**Armsby Road Culvert Replacement
Walworth County
Town of Linn, Wisconsin**

The following changes shall be incorporated into the Armsby Road Culvert Replacement Contract Documents:

NO.	REVISIONS	DATE	BY
1	ADDENDUM #1	7/23/24	DKV

SHEET NO.
C502

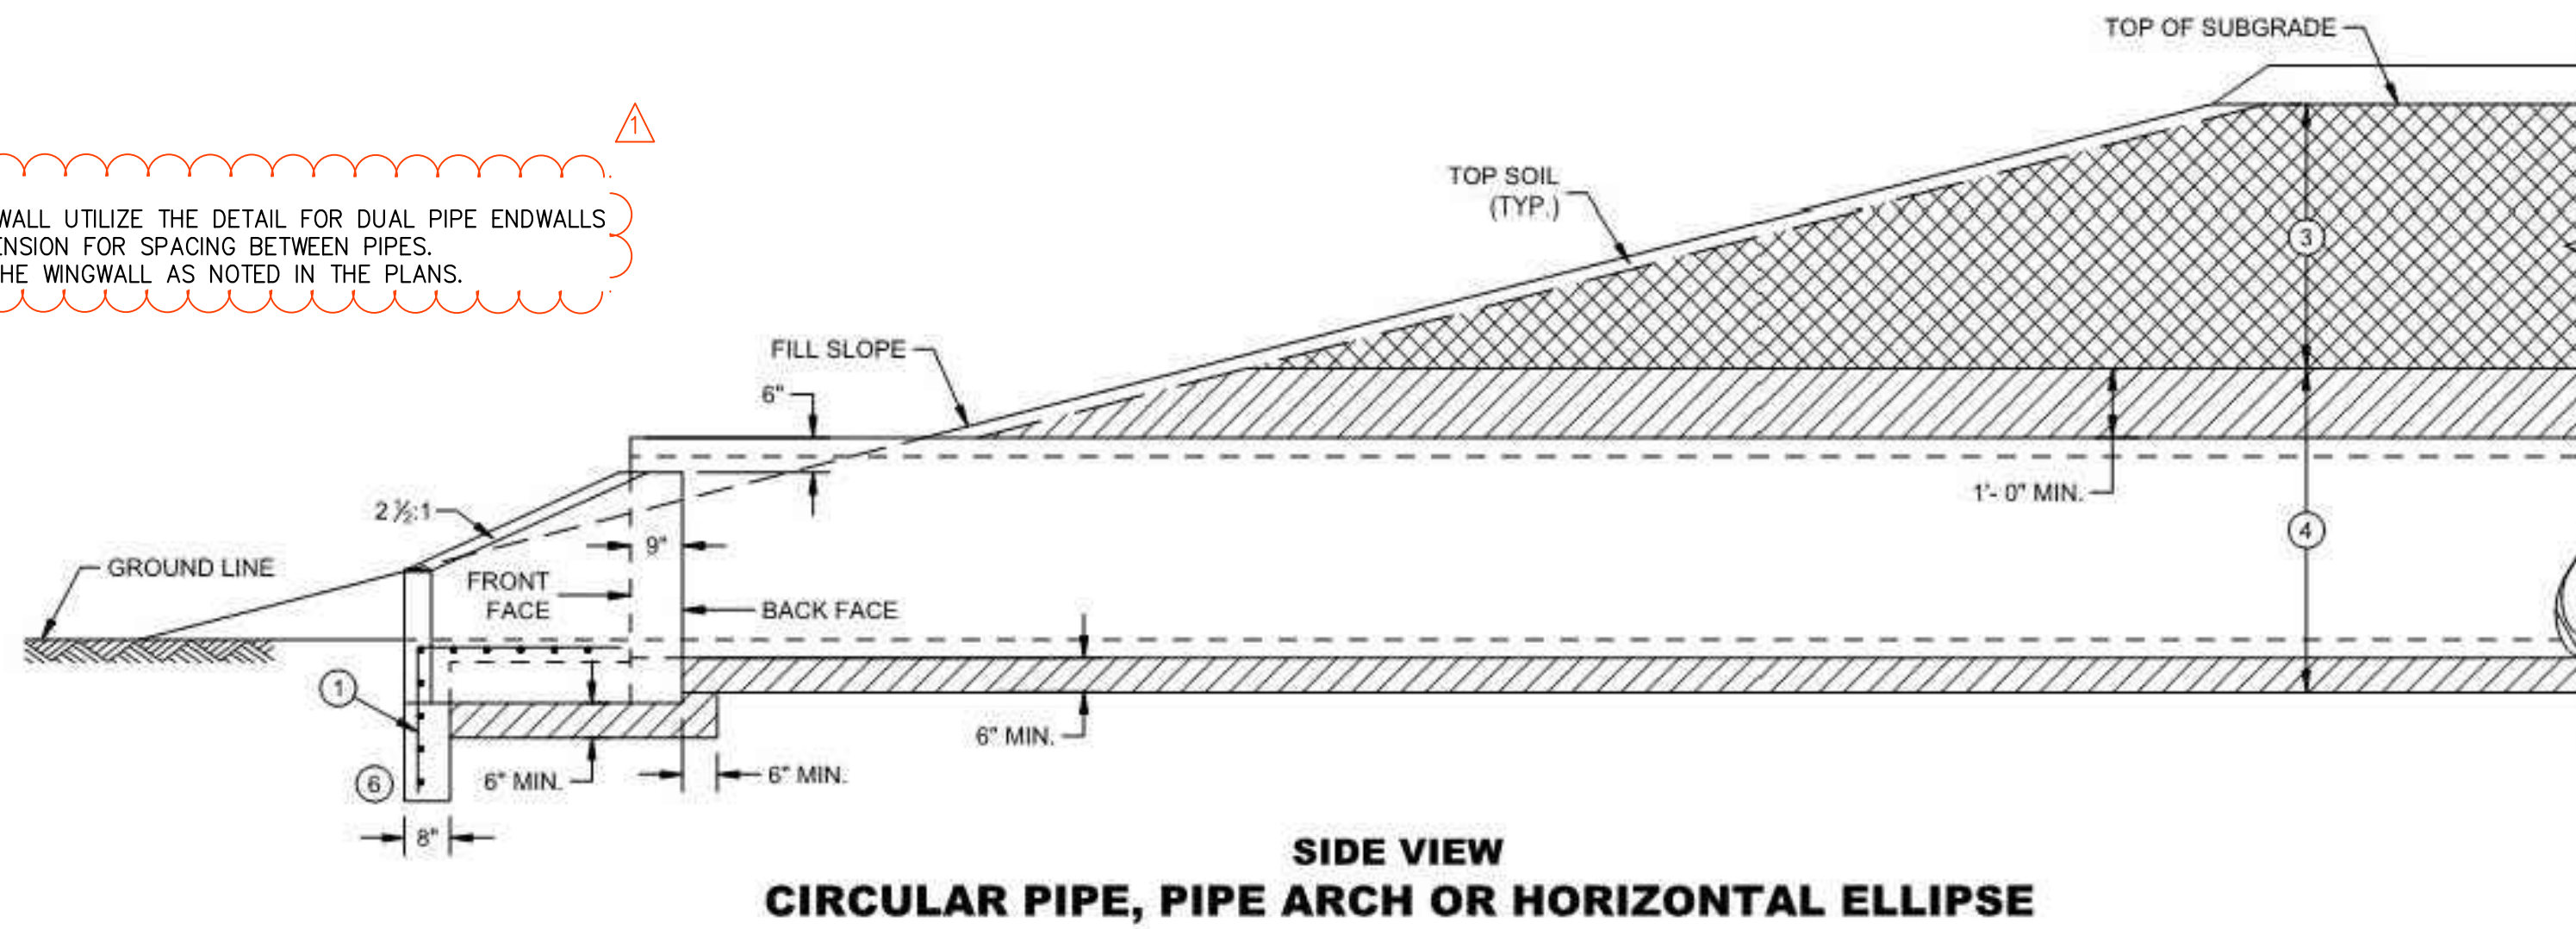
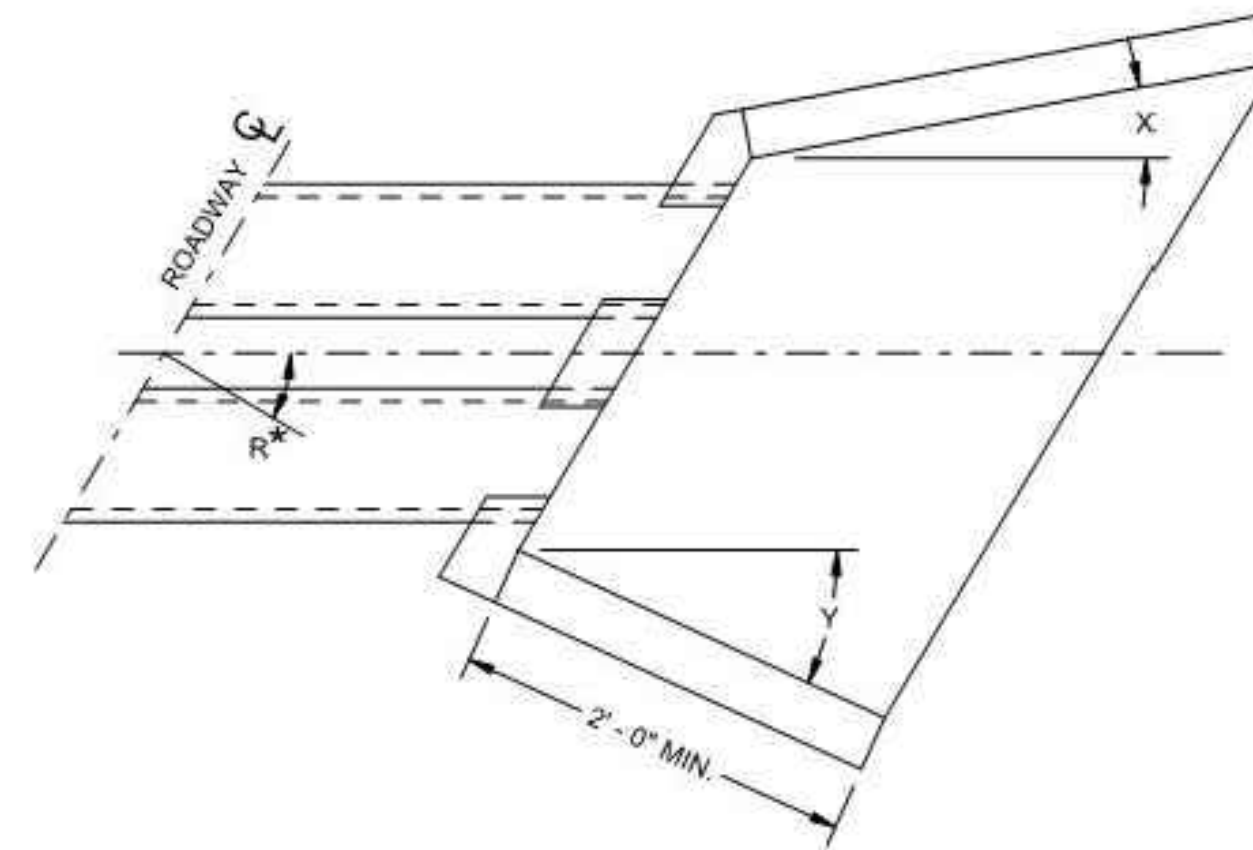
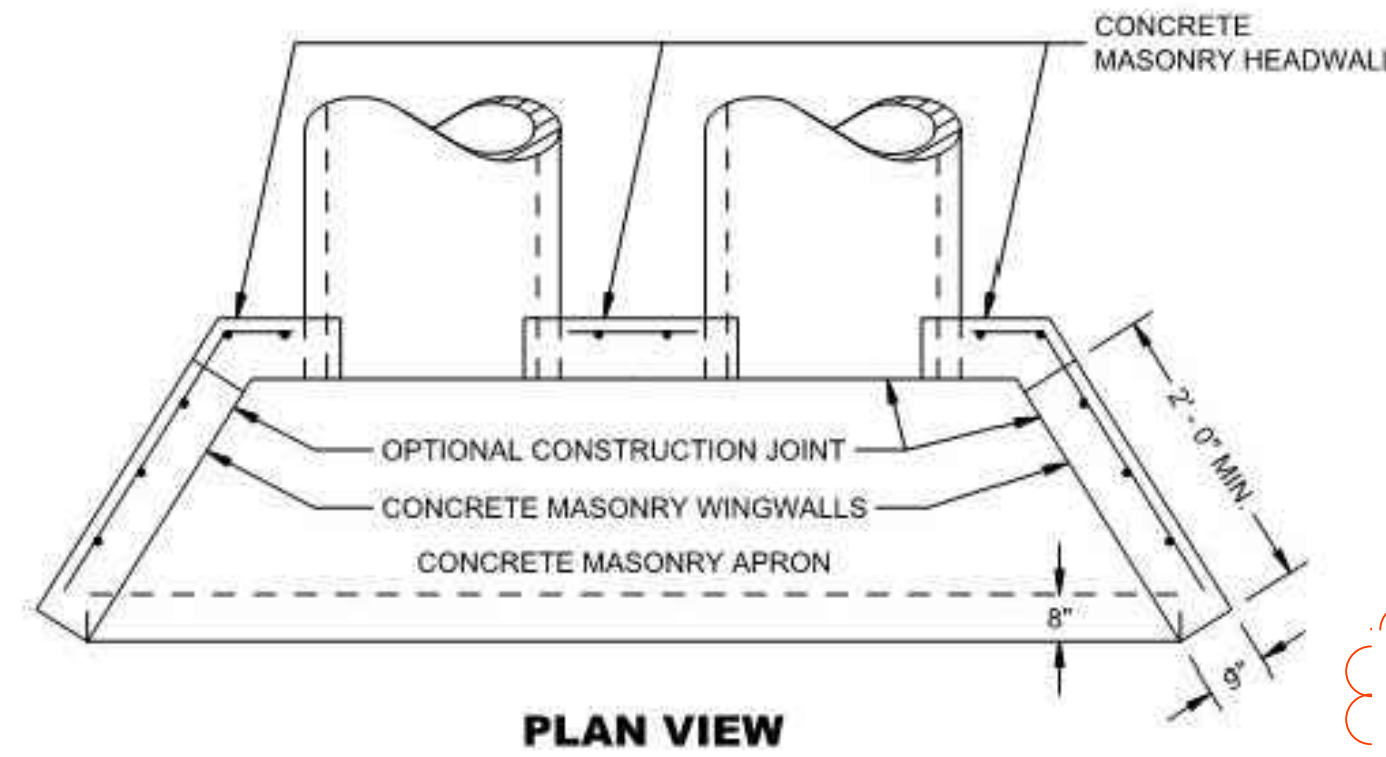
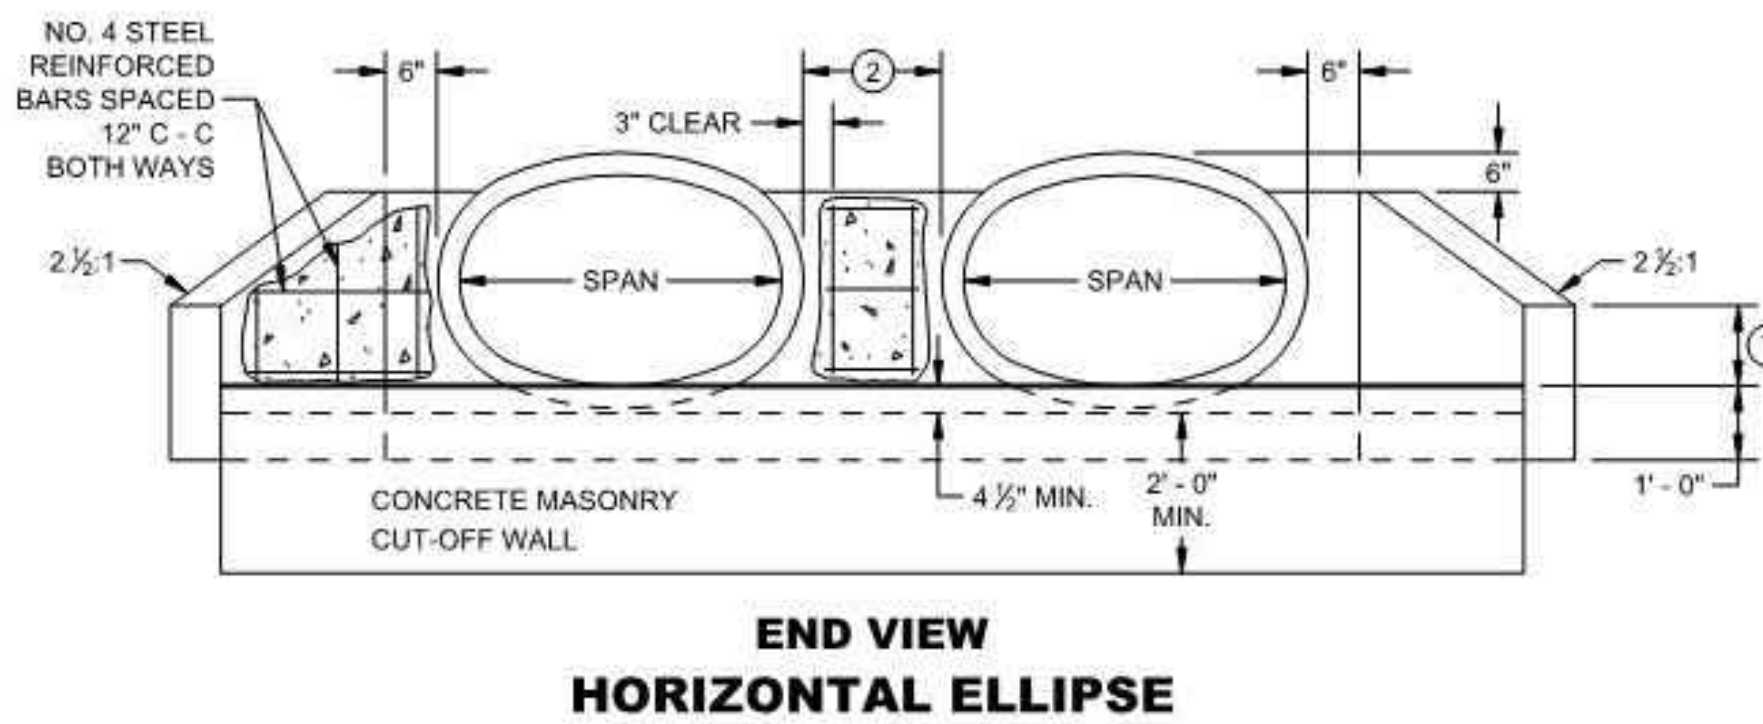
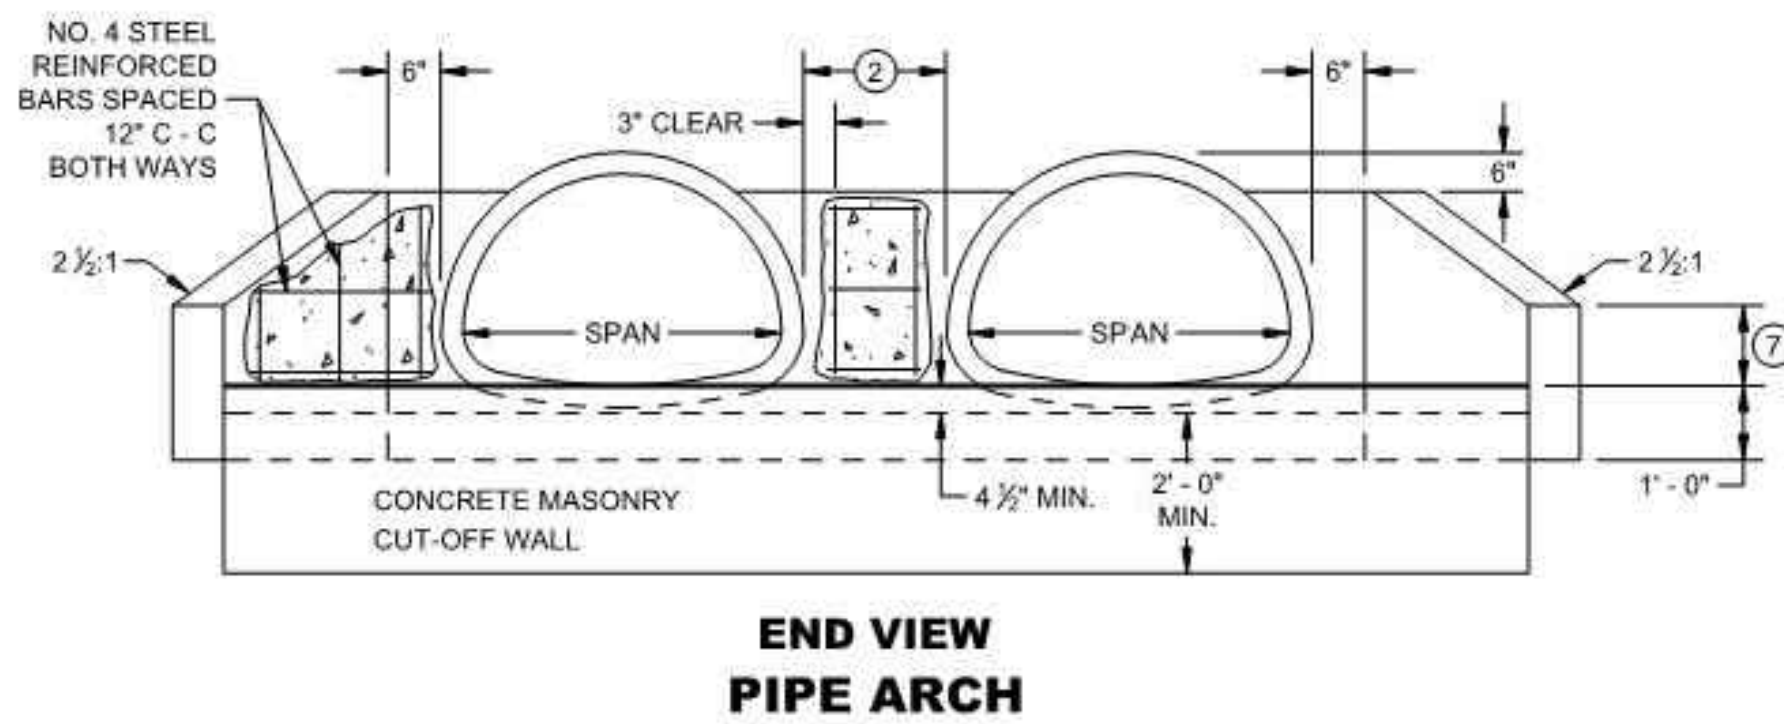
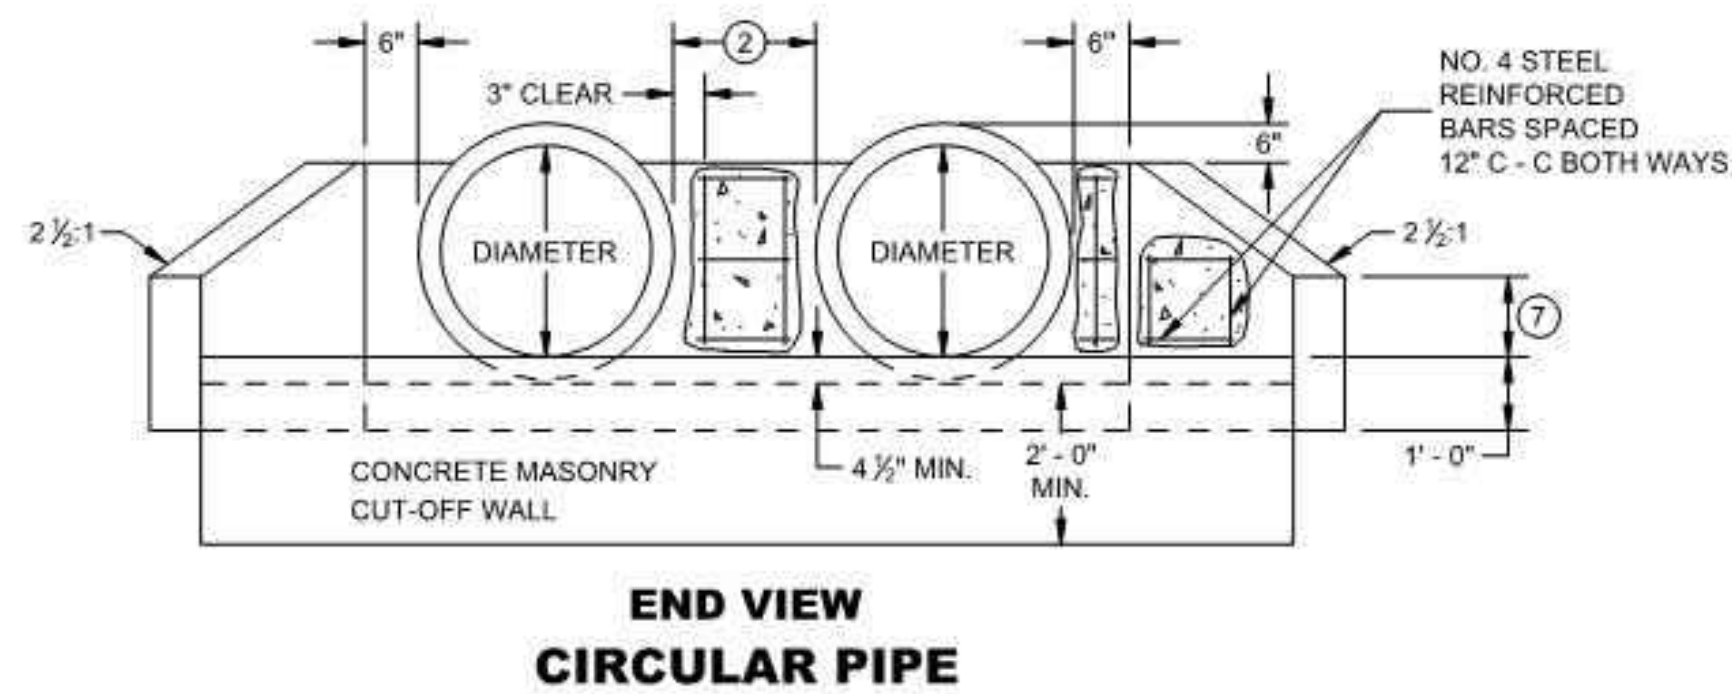
- III. **Replace Plan Sheet C502. Clarification has been added to the dimensions of the masonry endwall detail.**
- IV. **The attached Bid Form shall be used in lieu of the existing Bid Form.**
